DEVIATION REVIEW AND DECISION FORM

Subdivision or Project Name: Saddlehorn Ranch Preliminary Plan

Section of ECM from Which Deviation is Sought: Standard Drawings for Rural Local Roadways
Specific Criteria from Which a Deviation is Sought: ECM criteria for minimum rural local centerline radius

REDUCED RADIUS VARIANCE REQUEST

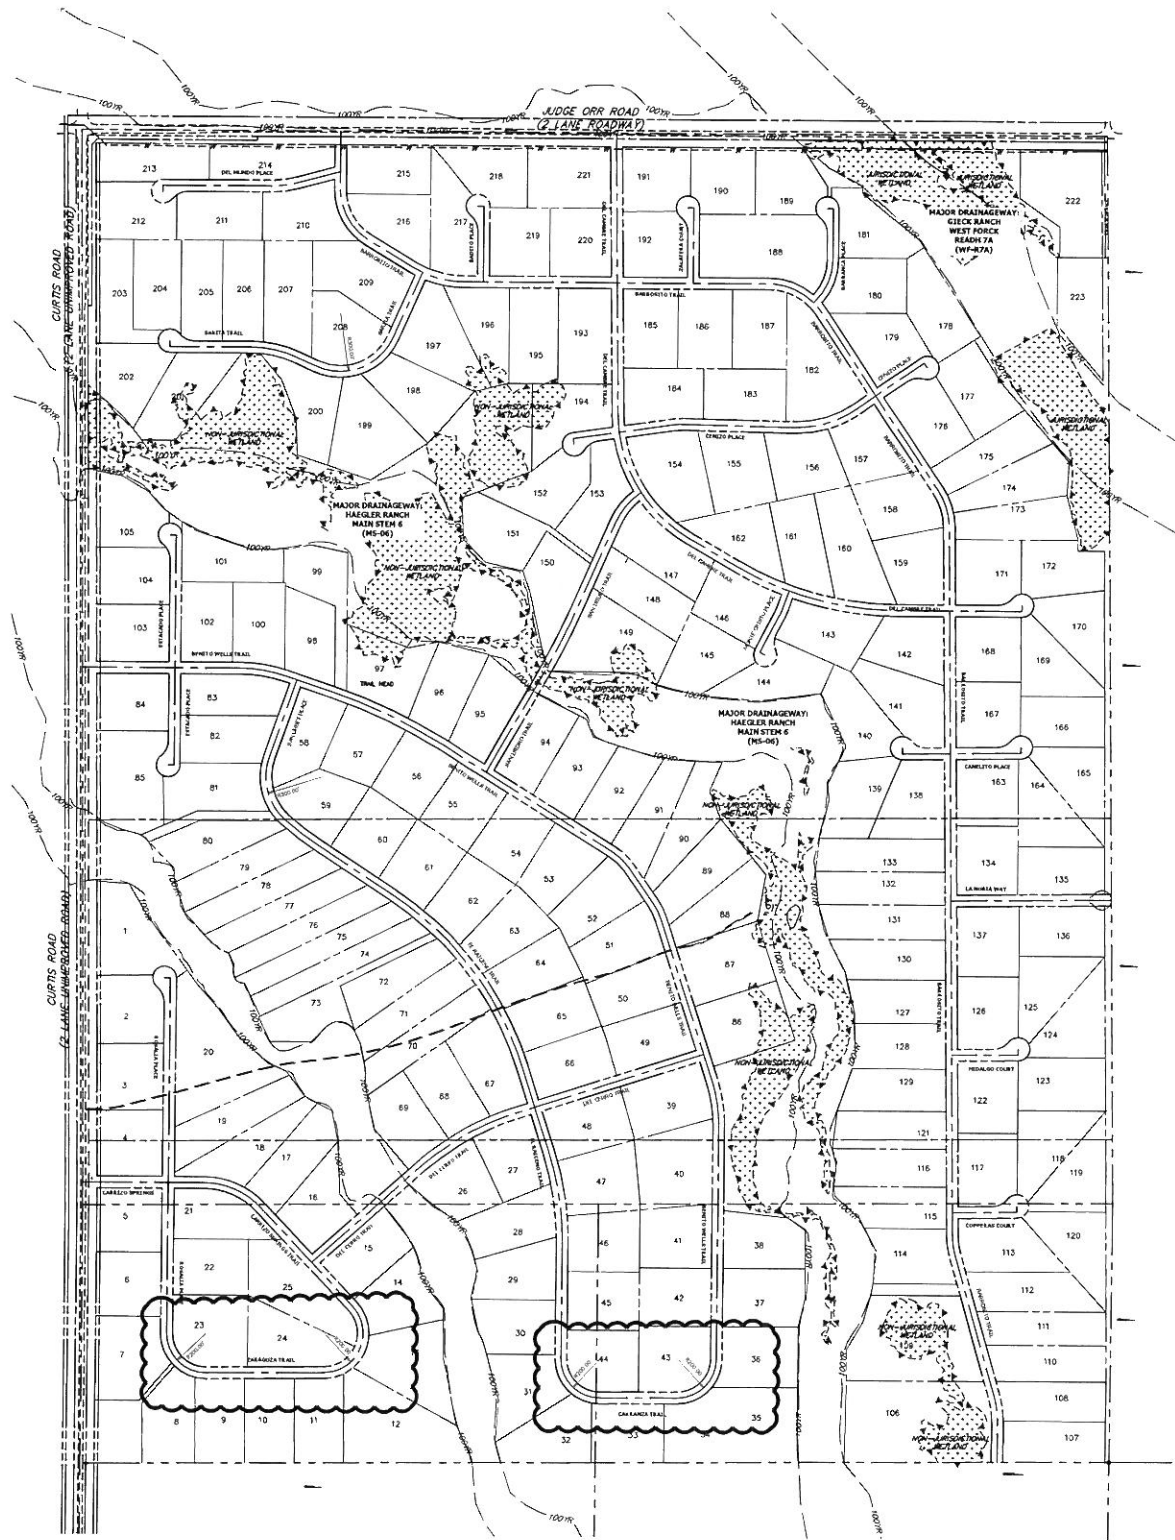
Proposed Nature and Extent of Deviation: Applicant wishes to use a 200 ft. radius at four locations shown on Attachment 1.

Proposed Nature and Extent of Deviation: Applicant wishes to use the urban local centerline radius in 4 locations within the property as opposed to the rural local centerline radius of 300 ft.
See Attachment 2 for ECM criteria for rural local centerline radius
See Attachment 3 for ECM criteria for urban local centerline radius for comparison

Reason for the Requested Deviation: Applicant believes the reduced radius is appropriate for the roadway geometry at the four locations requested.

Comparison of Proposed Deviation to ECM Standard: See Attachment for impact of using minimum roadway centerline radius at proposed locations. The proposed deviation is a 200 ft. centerline radius as compared to the ECM standard radius of 300 ft. centerline radius.

In the four locations where the deviation is requested, the natural features of the site (floodplain constraints and nearby Curtis Road) lends itself to the use of a "reduced radius" to create an efficient layout. Each area serves less than ten lots. Use of the required 300 ft. centerline radius would create the need for either excessively long flag lots or excessively large lots for the underlying R2.5 zoning

Use of standard radius curves would create excessively large lots in these specific areas or create the need for excessively long flag lots or create excessively large lots. If deviation granted applicant would reduce the posted speed from 30 mph (rural local) to 25 mph (urban local). The daily traffic volume on these streets is minimal, each location only serves 10 or less nearby lots.

This request has been determined to have met the criteria for approval. A deviation from Section 2.3.2 of ECM is hereby granted based on the justification provided. Comments:
